**Staff Report  
Cascade River Ranch  
ANNEX-19-01**

Staff: Heather M. Soelberg  
Public Hearing: July 8, 2019  
Applicant: Steve Arnold, A-Team Land Development & Real Estate  
Owner: Cascade River LLC  
Location: North-east of Highway 55, adjacent to the Payette River  
Size of Site: 121.17 acres  
Existing Zone: Mixed Use (MU)  
Proposed Use: Mixed Use Subdivision

**Staff Report**  
**Cascade River Ranch**  
**ANNEX-19-01**

Subject: Cascade River Ranch Preliminary Plat

**FIGURE D103.1  
DEAD-END FIRE APPARATUS ACCESS ROAD TURNAROUND**

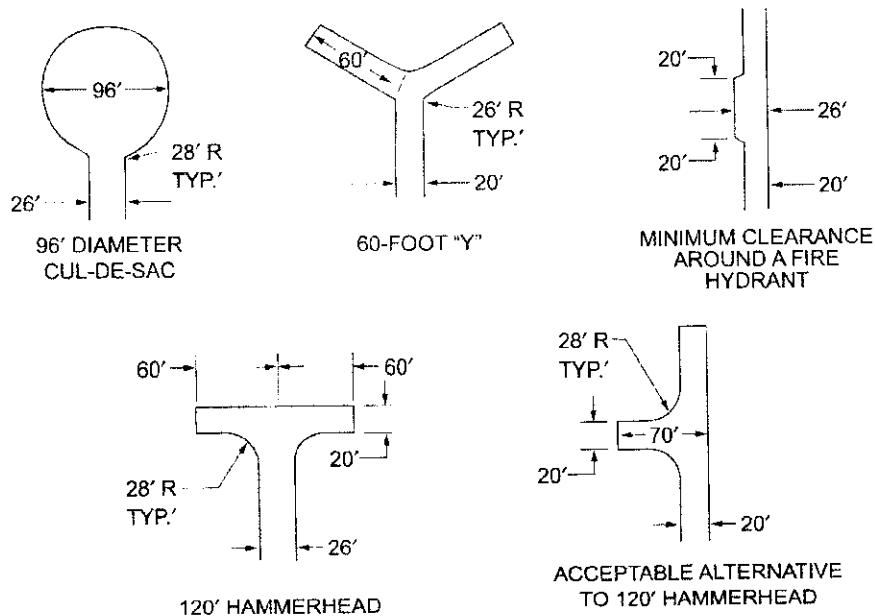
- b) All dead-end road and cul-de-sac shall meet the requirements in IFC Appendix D Figure D103.1 (attached).
- c) Fire flow for buildings shall meet the requirements in IFC (Appendix B) attached.
- d) Fire hydrant location shall meet the requirements in IFC Appendix C (attached).

- All roads shall be built to City of Cascade standards or Section 503.2 IFC 2015.
- All dead-end road and cul-de-sac shall meet the requirements in IFC Appendix D Figure D103.1 (attached).
